ADDENDUM TO THE FINAL WORK PLAN FOR NON-TIME CRITICAL REMOVAL ACTION AT
FORMER WASTE DISPOSAL PITS 1 AND 3 NIROP ROCKET CENTER WV
10/9/2013
AGVIQ/CH2M HILL

RE: Contract No. N62470-08-D-1006
Task Order No. WE28
Allegany Ballistics Laboratory – Rocket Center, West Virginia
Addendum to the Final Work Plan - Non-Time Critical Soil Removal Action Former
Disposal Pits 1 and 3, Allegany Ballistics Laboratory (ABL), Rocket Center, West Virginia

Responses to NAVFAC Comments (received on September 30, 2013) on the 100% Draft Final Drawings - Non-Time Critical Soil Removal Action Former Disposal Pits 1 and 3, ABL, Rocket Center, West Virginia

2 DETAIL
NTS

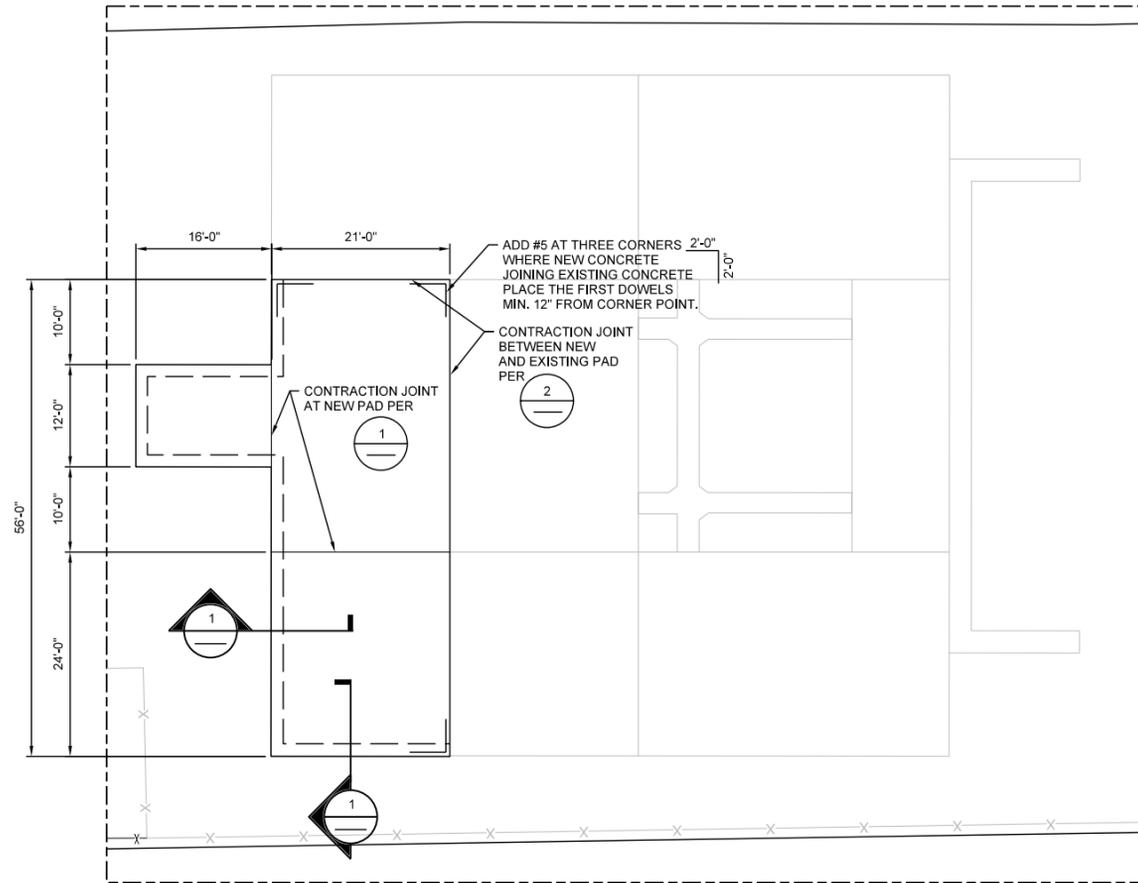
2. COMMENT: This is also a construction statement from C-004 and detail #2, that shows the use of steel dowels in the contraction joints and I assume that there will be dowels on two sides, as shown in the plan? I have two concerns, one is that you may want to be careful in the delta of the corner joint in having dowels in two directional planes too close together. This can lead to the concrete under heave pressure cracking or popping in the delta between them. Also, please ensure that prior to and during concrete placement that the dowels are maintained in horizontal placement, as this is a pet peeve of mine and prevents cracking and other slab defects.

RESPONSE: On Sheet C-004, a #5 corner bar was added at each of the three corners adjacent to existing pad to ensure no cracking at the corner. Notes were added on Sheet C-004 requiring first drilled dowels from corner shall be located 12 inches away from the corner point so the dowels are not too close to each other. Lastly, an addition to NOTE 6 of C-004 states that dowels are to be maintained in horizontal positions prior to and during placement.

CODE NO. 80091
 SCALE: AS NOTED
 EFD NO.
 STA. PROJ. NO.
 SPEC. NO.
 CONSTR. CONTR. NO. N62470-08-D-1006
 NAVFAC DRAWING NO.
 SHEET OF
C-004

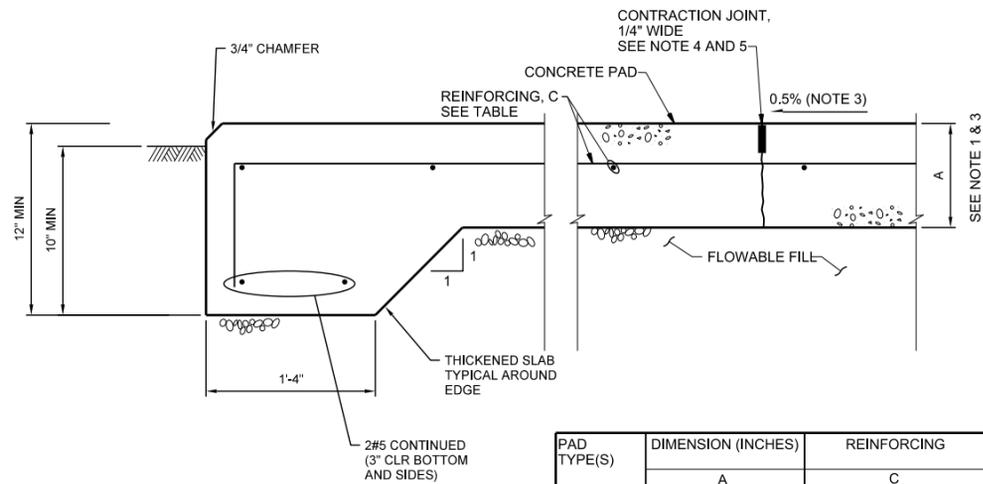
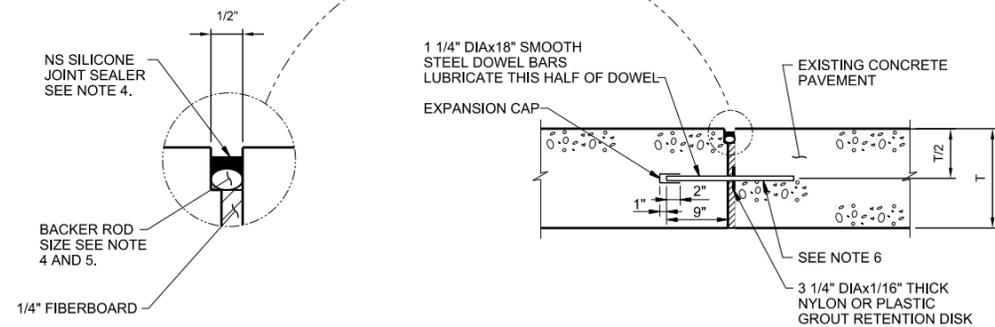
1. COMMENT: The detail and notes on C-004 for the construction joint and sealant placement in the 1/2" joint opening detail a "Sealant", has the joint sealant been specified? If so, are we matching the existing burn pad construction? If so, I know that the area in question should be out of the burn area and there is a burn pan on the pad for containing the XO, however, will the sealant used be susceptible to heat deterioration? I am unsure of the existing condition, but the pad use may be an issue for the joint detailed, nor do we want to trap any residue materials, nor be cleanable. This is a typical construction joint and will probably use industry standard concrete caulk.

RESPONSE: We selected Non-Sag Silicone sealant as specified on Sheet C-002. Non-Sag Silicone sealant is recommended in an Engineering Technical Letter 02-8 by the Department of The Air Force (see attached) for sealing joints in concrete pavements on Air Force airfields. The Non-Sag Silicone sealant is required to meet SS-S-200E Section 4.4.12 for Flame Test Requirements, which states "the sealant shows no sign of ignition, support of combustion, hardening, or loss of flexibility, flow or separation during heat exposure, or upon cooling, or any separation or loss of adhesive strength between sealant and concrete, when exposed to a temperature of 260 C (500 F) for 120 seconds". The portion of the pad that is being replaced is not directly under the burn area but may be subjected to some residual heat. Two products are listed on Sheet C-002 in the specifications that meet this requirement.
